**Staff Report to the
Municipal Planning Board
July 21, 2020**

**ZON2020-10009
MPL2020-10037**

MARIPOSA GROVE PD

Detailed Site Plan

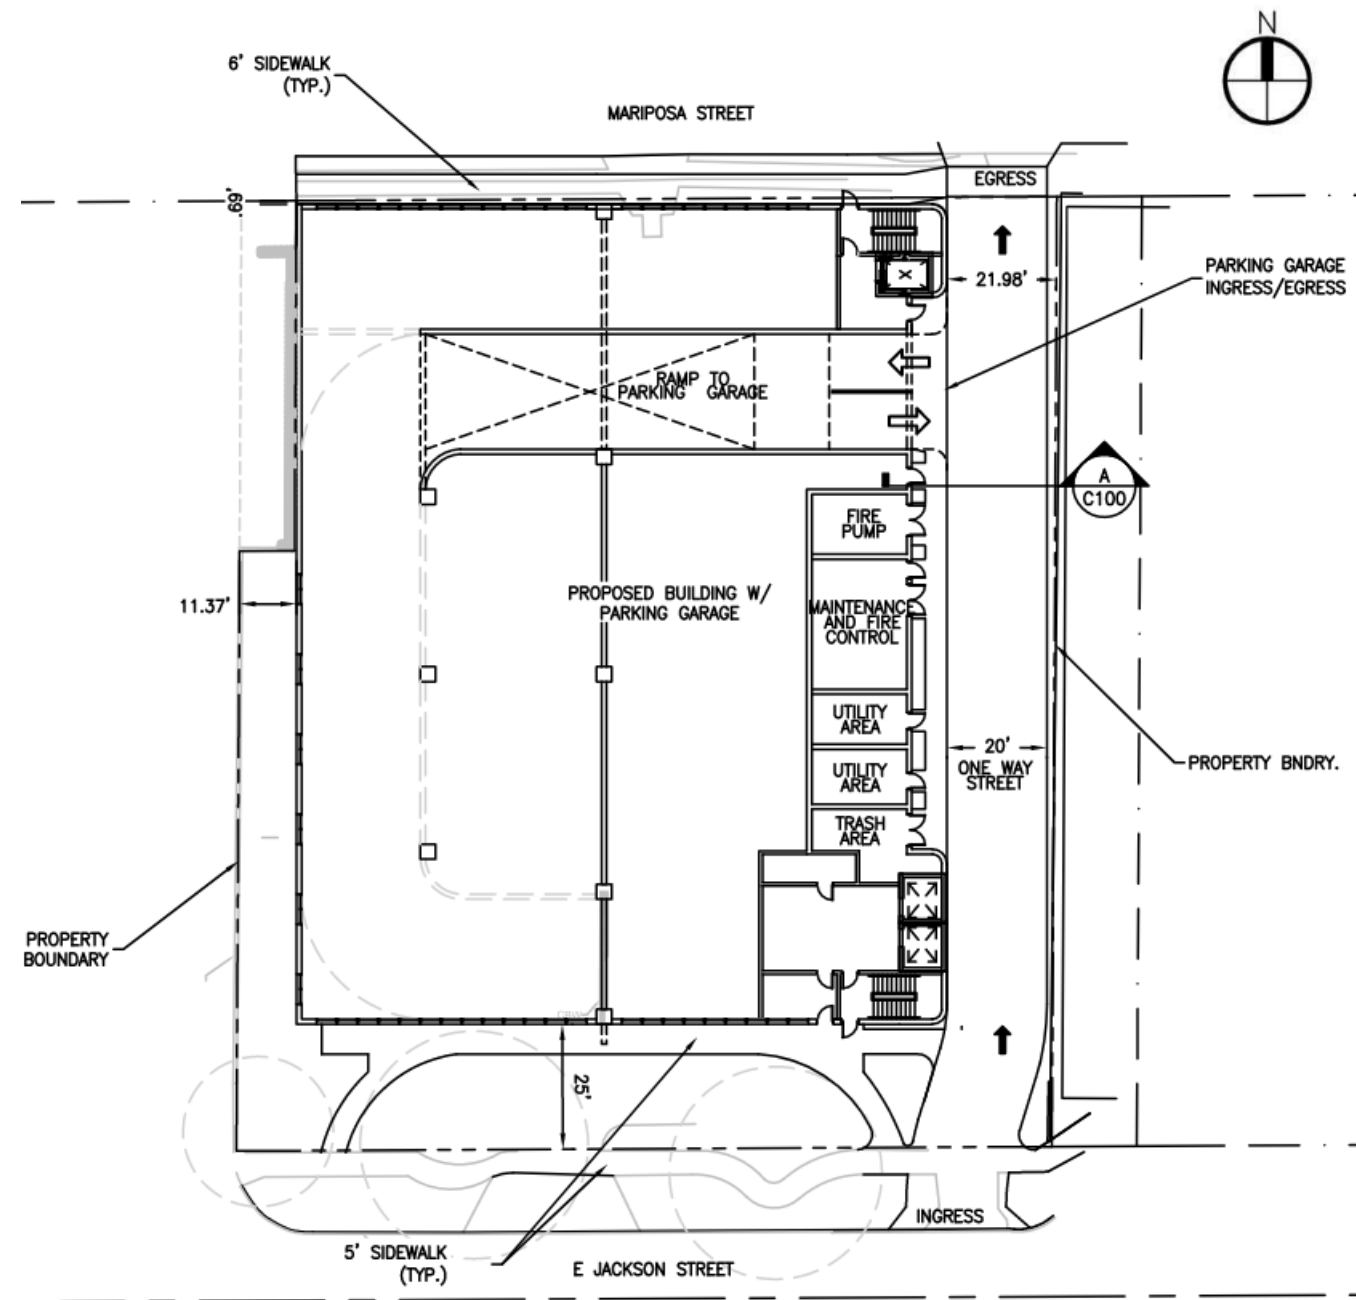
6. **Setbacks.** The subject property must have a minimum front yard setback of 0 ft. and a maximum of 5 ft., a western side setback of 0 ft., an eastern side setback of 0 ft. and a rear yard setback of 25 ft. The front shall be deemed Mariposa St. and the rear shall be E. Jackson St.

2. **Sight Distance.** At all project entrances, clear sight distances for drivers and pedestrians must not be blocked by signs, buildings, building columns, landscaping, or other visual impediments. No structure, fence, wall, or other visual impediment must obstruct vision between 2 feet and 8 feet in height above street level. The street corner / driveway visibility area must be shown and noted on construction plans and any future site plan submittals. The applicant must design the site plan as necessary to comply with the Florida Greenbook and the FDOT Design Standards Index. Sight lines must be provided on both site plans and landscape plans.

3. **Solid Waste.** The final site plan must show the location and size of the on-site solid waste compactor(s) / dumpster (s) with concrete pads, and enclosures with doors. The solid waste container(s) must not be located adjacent to any single-family houses or directly adjacent to the public street. Dumpsters must be located to provide a minimum 50 feet of clear backup space and constructed per Orlando Engineering Standards Manual (ESM) requirements, OR documentation must be provided from the City's Solid Waste Division indicating curb pick-up or other approved arrangement.

1. Fire resistance ratings requirements for exterior walls based on fire separation distance shall comply with FBC Table 602. Ref: North East Corner openings in exterior wall at this location shall comply with FBC Table 705.8.

Streetscape Cross Sections

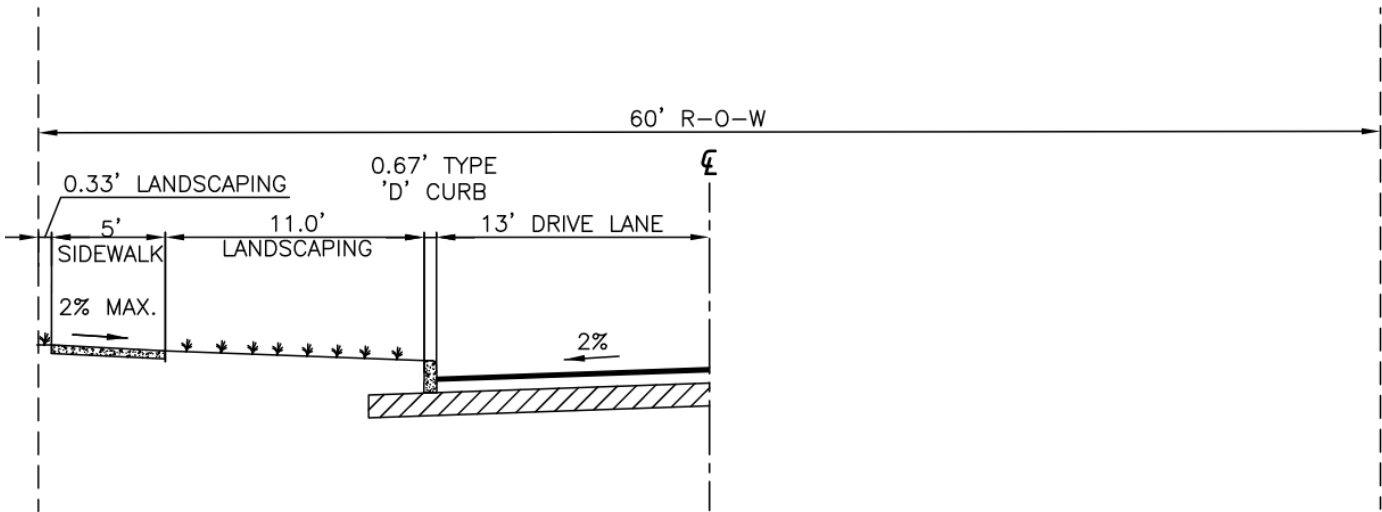
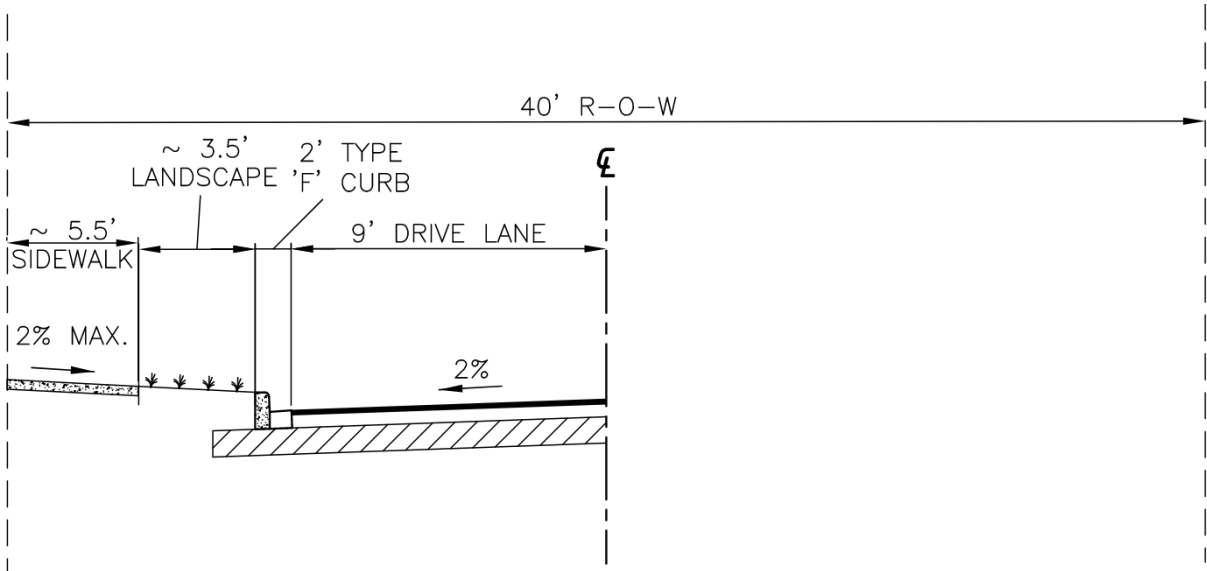
5. **Streetscape.** A minimum of 12 ft. streetscape along Mariposa and 15 ft. streetscape along Jackson per the Downtown Streetscape Standards and the South Eola Small Area Plan is required. Sidewalk may be narrowed to avoid impacting trees on Jackson. However, sidewalk must not reduce to less than 6' in width when going around the trees.

6. The South Eola Small Area Plan requires on street parking to be included adjacent to this property on Mariposa Street. Due to the increased setback provided on Jackson Street in order to preserve existing trees, staff approves an exception to this streetscape to remove the requirement for on street parking.
